Reviewer1

accepted subject to technical corrections

Reviewer2

General comments. The revised paper is improved from the earlier version. The authors have clarified several parts of the text that were not clear before, and generally did a good job addressing the previous reviews in my opinion. They also made it clear that the purpose of this paper is “proof of concept” of the new approach to demonstrate initial results for the GDMN approach implemented in a 3D model (WRF). The authors also performed 1 month simulations and showed marginal improvement in skill scores using GDMN compared to the original WDM6 (it’s not clear if these simulations were short simulations re-initialized every few days, or a single month-long simulation). The results from these simulations were shown in the author’s reply to my previous review. I think they should consider moving this into the main paper. A few other major comments are given below – nothing critical, but some additional points that I feel the authors should address before publication. Several minor and editorial comments and suggestions are listed after.

Figure R1. Same as Figure 7 in the revised manuscript.

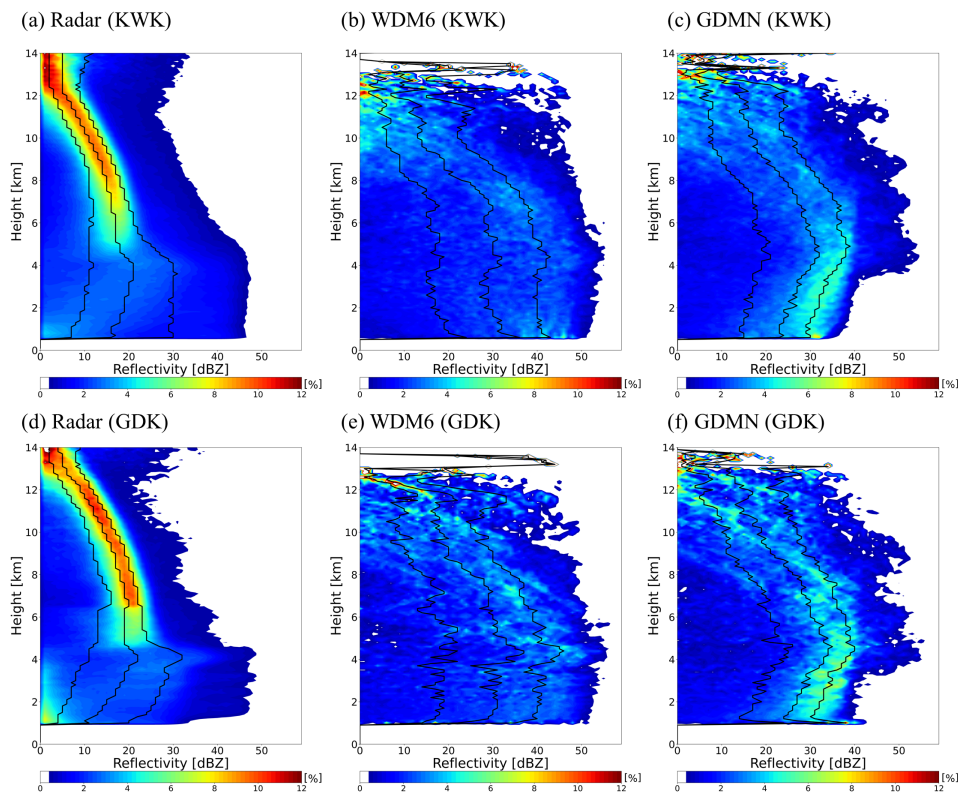
2. I raised a similar point in my previous review: In Figure 7a, the cumulative reflectivity does not look correct (black lines) relative to the CFAD in color contours for the observations at heights below ~4 km. The authors mentioned there is no bug, but I don't understand how the color contours and the cumulative distributions can be mismatched. Below 4 km, the black lines (cumulative distributions) don't even align with the CFADs, the black lines are relatively constant with height while the CFAD colors show angled increase with height. Are the cumulative distributions not being calculated over the full distributions? That is, is some lower cutoff being used for the cumulative distribution function? That's the only thing I could see that might potentially explain the discrepancy.

3. Lines 333-343. Overall, the GDMN improvements relative to the original WDM6 still seem overstated. I disagree with some of the discussion based on Fig. 7. Where is the bright band evident in GDMN (as stated on line 337)? The narrow bright band is clearly seen in the observations for both cases, with a sharp shift in the CFAD to larger reflectivities (moving downward with altitude) right around 4 km. No such trend is seen in either WDM6 or GDMN. GDMN has a very broad region of higher reflectivity between 4 and 7 km, but this is not a bright band (e.g., it extends well above the melting level). Thus, please modify the statement about the bright band in GDMN to better reflect the results shown in Fig. 7.

Second, both GDMN and WDM6 seem about equally biased with reflectivities that are too large above 6 km. Particularly above 9-10 km, both schemes produce cumulative 50th and 75th percentile reflectivities of 20-30 dBZ while the observations are less than 20 dBZ for the 75th percentile. The GDMN reflectivities are perhaps slightly lower and thus closer to observations, but the difference is small. In other words, the differences between GDMN and WDM6 are much smaller than differences between these schemes and the observations at these altitudes. Thus, I think that the discussion on lines 340-342 needs to be modified. Overall, the main difference is that GDMN reduces the reflectivity high bias in WDM6 below 4 km. That is a nice result, and I feel this should be emphasized by the authors rather than trying to claim substantial improvements for ice-phase regions aloft that are much less clearly seen in the figure.

: We sincerely thank the reviewer for pointing out this issue. In the original analysis, reflectivity values between 5 and 60 dBZ were included in the CFAD calculation, while values outside this range were excluded using cutoff thresholds. Following the reviewer's suggestion, we have revised Figure 7 to include reflectivity values between 0 and 60 dBZ, excluding only values below 0 dBZ (Figure R1). The revised figure shows more improved agreement between the cumulative reflectivity (black contours) and the CFAD (colored shading), compared to the previous version. Accordingly, the corresponding description in the manuscript has been revised from "The reflectivity values range from 5 to 60 dBZ." to "The reflectivity values range from 0 to 60 dBZ."

: We thank the reviewer for this valuable comment. Accordingly, we have revised the manuscript to describe this reflectivity enhancement more cautiously.

The description of the KWK case has been revised from “GDMN shows a bright-band signature at 5 km and a decrease in reflectivity near the surface, indicating possible substantial evaporation in the lower layers.” to “Although GDMN does not reproduce the narrow, distinct bright band observed near the melting layer likely due to the forward operator within WRF, it well reproduces reflectivity intensity below 4 km, bringing it into better agreement with the observations. GDMN also shows a decrease in reflectivity toward the surface, indicating possible substantial evaporation in the lower layers.”

For The description of the GDK case, we have deleted following sentence “In contrast, GDMN simulates a clear bright band at around 4 km, with a median reflectivity of 35 dBZ.”

We have moderated the discussion regarding the upper-level reflectivity structure from “Although discrepancies with the observations still remain after applying the GDMN approach, GDMN reduces the overestimation of reflectivity and provides a more realistic representation of solid-particle growth at upper layers, compared to WDM6.” to “Although discrepancies with the observations still remain after applying the GDMN approach, particularly above approximately 6 km, GDMN overall reduces the overestimation of reflectivity compared with WDM6.”

Figure R2. Spatial distribution of hourly precipitation [mm hr^{-1}] from (a) the IMERG observations and model simulations using (b) WDM6 and (c) GDMN for the one-month simulation conducted during July 2023.

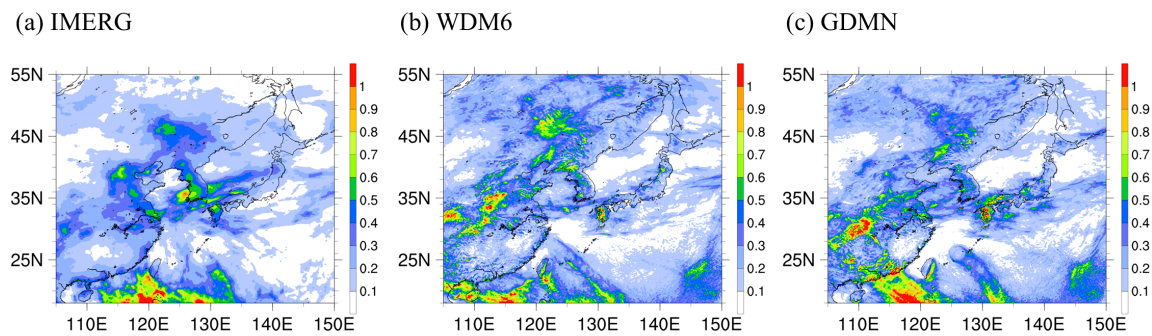
4. Why not include results from the 1 month simulations that you mentioned in your reply to my previous review? This provides useful context and there should be enough room to include it.

: Following the reviewer's recommendation, we have included the results of the one-month simulations in the revised manuscript as Figure 14 (Figure R2 in this responses), with the corresponding discussion in the “Summary and Discussion” section to provide additional context for the performance of the GDMN approach.

“To address the limitations of the single-case analysis, we additionally conduct a single month-long simulation over East Asia for July 2023, encompassing a wide range of summertime convective systems. The model configuration, including the physical parameterizations and initial and lateral boundary conditions, is identical to that used in the single-case simulation, except that a horizontal grid spacing of 10 km and a model time step of 60 s are employed. Sea surface temperature (SST) is prescribed using the Optimum Interpolation SST (OISST) dataset (Huang et al., 2021). The performance of the original WDM6 and the modified WDM6 is evaluated against hourly precipitation from the Integrated Multi-satellite Retrievals for GPM (IMERG) product (Huffman et al., 2015) (Fig. 14). Compared with the original WDM6, the modified WDM6 scheme reduces the precipitation over Northeastern China and increases the precipitation over the South Sea of Korea, resulting in better agreement with the observations. The statistical skill scores for surface precipitation also demonstrate the improved performance of the modified WDM6, with the pattern correlation (PC) increasing from 0.47 to 0.52 and the bias decreasing from 1.04 to 1.02. These results indicate that the performance improvements achieved by the GDMN approach are maintained in a one-month simulation encompassing a broad range of summertime convective systems, suggesting that its benefits extend beyond the single convective case examined in this study.”
